Subject: Final Report - DER 84-46  
A 50.55(e) Reportable Condition Relating to Refueling Water  
Tank Penetration Sleeves.  
File: 84-019-026; D.4.33.2

FINAL REPORT - DER 84-46  
DEFICIENCY EVALUATION 50.55(e)  
ARIZONA PUBLIC SERVICE COMPANY (APS)  
PVNGS UNITS 1, 2, 3

FIGURE 1

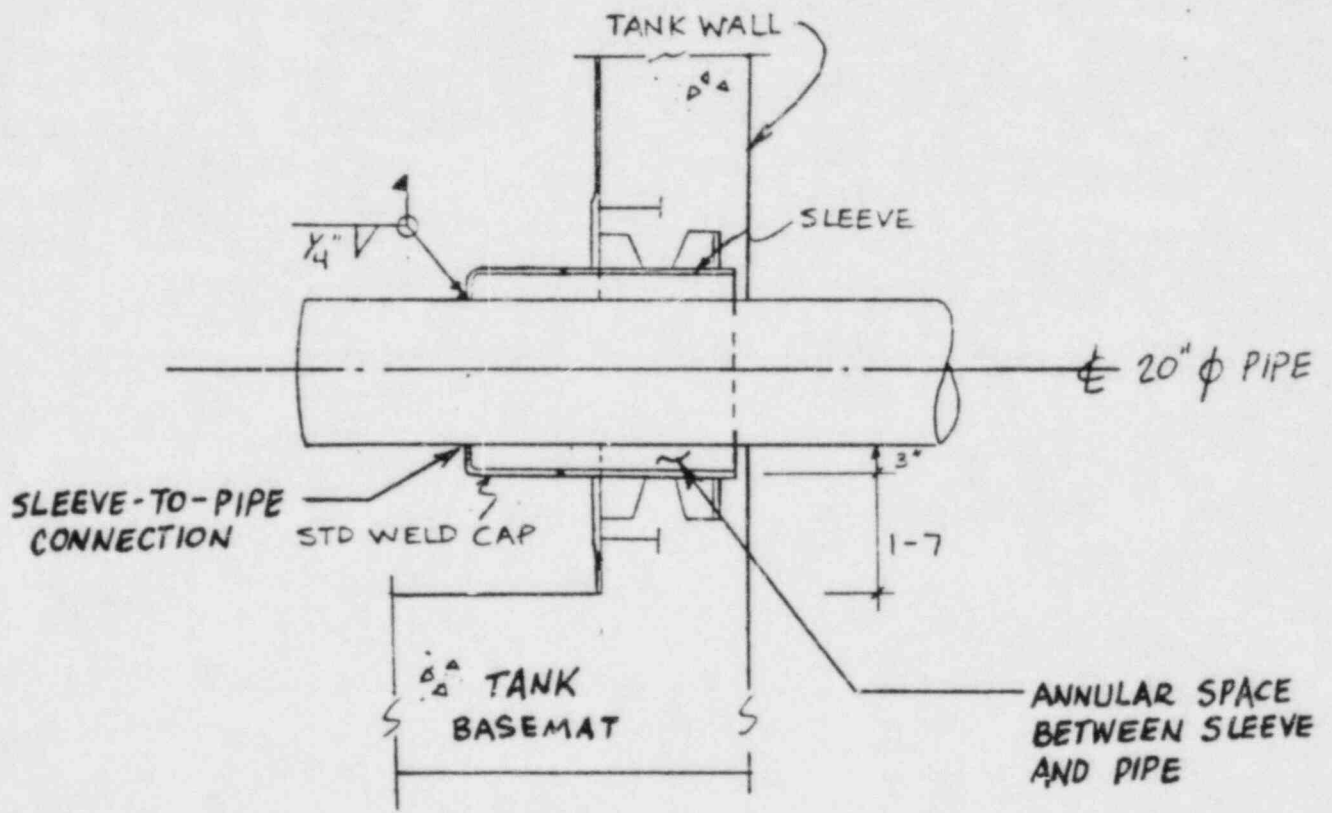
Following completion of the final stress calculation for the Chemical and Volume Control system (CH), it was determined that no design calculation had been performed for the sleeve-to-pipe cap plate connection for two 20-inch diameter pipes penetrating the Refueling Water Tank (See Figure 1). Calculations were performed and revealed that the connection would be overstressed during a seismic event due to loads resulting from seismic anchor movement.

In the original configuration, relative movement between the Refueling Water Tank and the Essential Pipe Tunnel during a seismic event would cause a relative transverse movement between the sleeve and the pipe. This movement created the overstress condition in the sleeve-to-pipe connection. To prevent this movement, the annular space between the sleeve and the pipe shall be filled with non-shrink grout. Calculation No. 13-CC-CT-015 has been performed to verify that this modification will prevent the overstress condition. This action will ensure that the system will not fail in the event of an SSE and that the leak-tight integrity of the Refueling Water Tank will be maintained.

Design Change Packages (DCPs) 1SC, 2CC, and 3CC-ZY-134 have been prepared and will be issued to perform and document the required grouting work for all 3 Units.
